WEST LINN PLANNING COMMISSION

FINAL DECISION NOTICE

DR-12-08/VAR-12-01

IN THE MATTER OF A CLASS II DESIGN REVIEW AND A CLASS II VARIANCE FOR CONSTRUCTION OF A CHASE BANK AT 19080 WILLAMETTE DRIVE

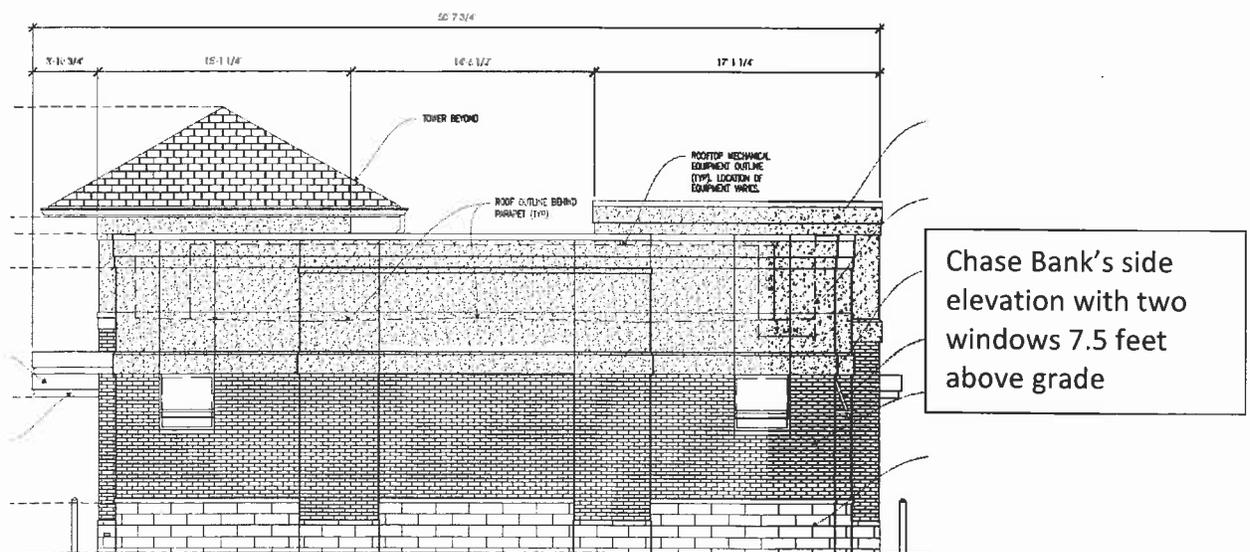
Since the clerestory windows do not factor into the transparency calculations because they are too high for people to look in or out of the bank and because most are for secure interior spaces the applicant has requested that they be opaque instead of clear. Staff can support the change from clear to opaque glass on those grounds and further notes that opaque clerestory windows will still help break up the elevations architecturally.

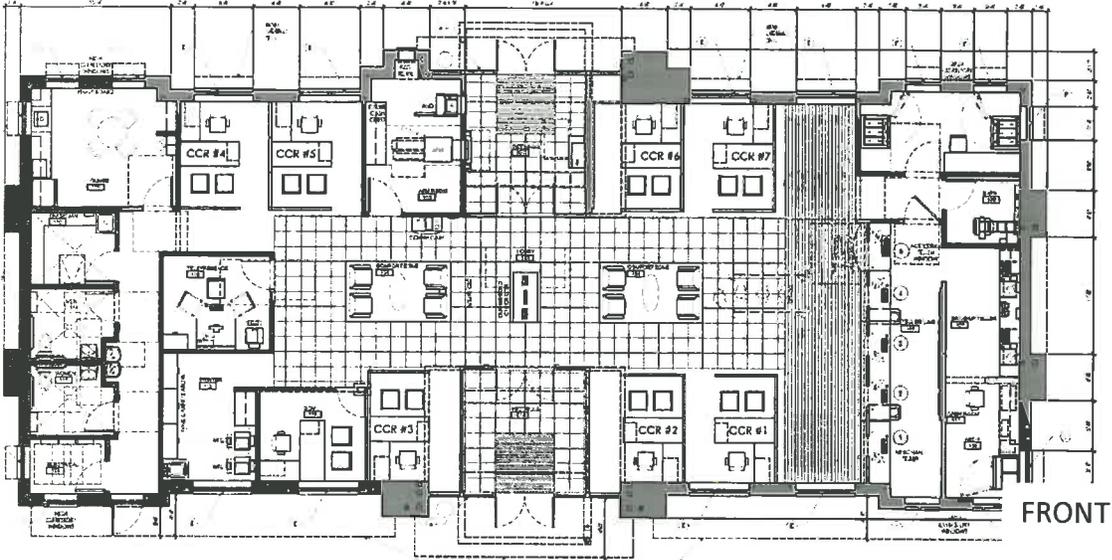
While the argument is compelling as it relates to the side elevations, particularly for those spaces that demand either privacy or deference to security concerns, there are portions of the front elevation does not suffer from those constraints. Staff finds that transparency can be added to the front elevation.

Adding nine feet of windows on the front elevation would increase transparency to 51.2%; still shy of the required 60%, but an improvement. Staff recommends approval of the variance with the condition that the transparency be increased as indicated in the drawings below and per proposed Condition of Approval 3.

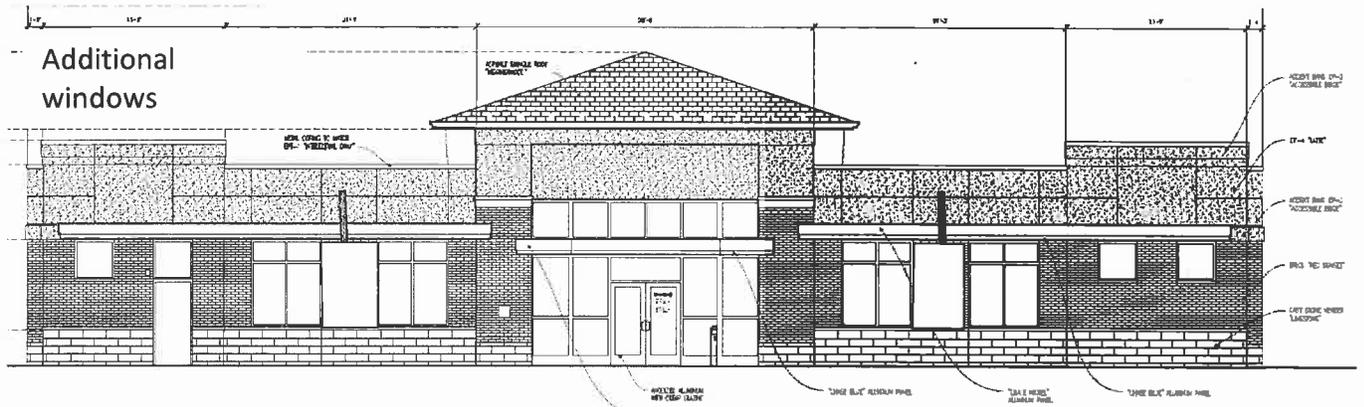
To minimize occurrences of customers leaving the bank property, driving 200 feet along Willamette Drive, then turning into the Willamette Village shopping center immediately to the north of the bank property, the owner of that property (tax lot 700 assessor's map 21E 23AA) was required by condition of approval to build a stub out driveway to allow easy vehicular connection between the two parcels. This would reduce vehicle loads on Willamette Drive and would also reduce potential turn conflicts on that street. The applicant's plans show this driveway connection. A mutual access easement will be needed to allow use of the driveways (see Condition 5).

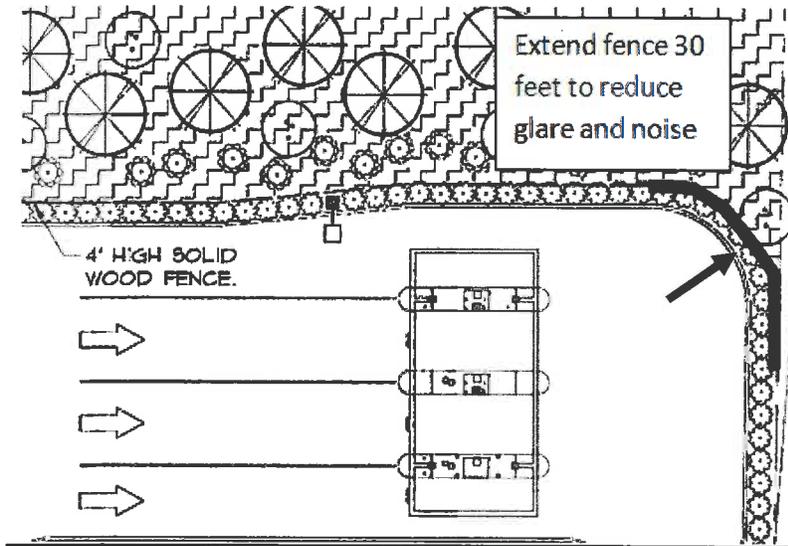
1. Approved plans. The approved site plan is the Landscape Plan, Sheet L-1, dated 4/23/2012. The approved elevation is Exterior Elevations Sheets A4.1 and A4.2 dated 4/11/2012 with window modifications per Condition of Approval 3 and no individualized awnings over clerestory windows.
2. Exterior building lighting. Colored illumination or colored lighting (e.g., blue) of the building exterior is prohibited.
3. Windows. At least nine lineal feet of additional windows shall be added at the pedestrian level to the front elevation. The window placement shall be consistent with, or similar to, the elevation below. New windows shall match proposed multi-light windows.
